INITIAL FIRE SAFETY INSPECTION REPORT

Factory Name: Unimas Sportswear Ltd. (New Expansion Building)

Date: 31 January 2022

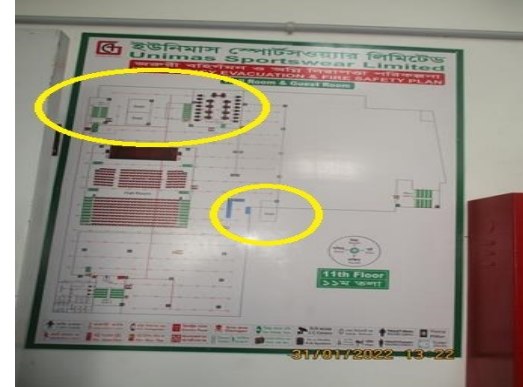
SI No.	Category	Findings	Required Action	Remediation Time Frame
F-1	Fire Rated Construction	<p>The exit stairs are not separated from work areas and other spaces on each floor by fire-rated construction.</p> <p>During inspection it was observed that the factory has installed fire doors at exit.</p> <p>Location: New expansion building.</p>	<p>Submit installed fire rated door documents to the RSC for review. Provide minimum 2-hr fire rated separation exit enclosure. Provide minimum 1.5-hr fire rated doors and seal all unprotected openings and penetration to separate the exit stairs from work areas and other building spaces on all floor levels.</p> <p>The clearance under the bottom of a fire door shall be a maximum of 19mm.</p> <p>Ensure that the fire doors are self-closing and positive latching and that they are provided with fire exit (panic) hardware where serving production floors. If fire doors are required to be held open for functional reasons, provide automatic closing devices tied to the fire alarm system.</p> <p>Once fire doors are installed, every door in a stair enclosure serving more than 5 stories shall be provided with re-entry unless it meets ACCORD standard 6.8.3.1.</p>	Within 3 months

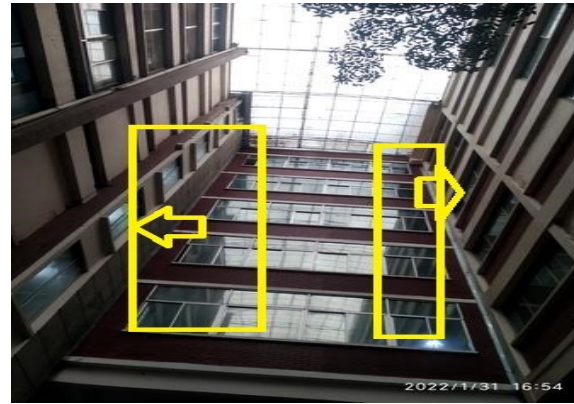
F-8	Fire Rated Construction	<p>Exterior exit stairs are not properly separated from the building.</p> <p>Location: Stair-3 & stair-7 of near building A & D</p>	<p>Exterior exit stairs shall be separated from the building with a rating requirement of [1 hr. fire rating for 3 or fewer stories or 2 hr. fire rating for 4 or more stories]. The rating of the exterior wall shall extend 3.05 m (10 ft) beyond the ends of the stair structure.</p>	<p>Within 3 months</p>
-----	-------------------------	---	--	------------------------

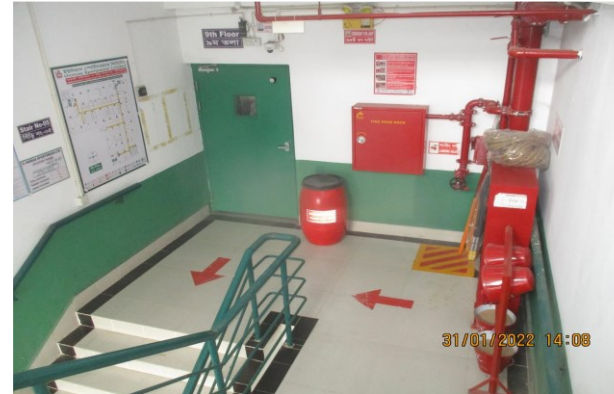
F-35	Fire Protection System(Standpipe)	Standpipe system installation requires detailed review to confirm compliance with NFPA 14 ,20 ,22 & 24	Submit as-built drawings, testing records, equipment certification and other relevant documentation to the RSC for review and approval/acceptance test.	Design within 2 months, Modification within 5 months (if required).
------	-----------------------------------	--	---	---
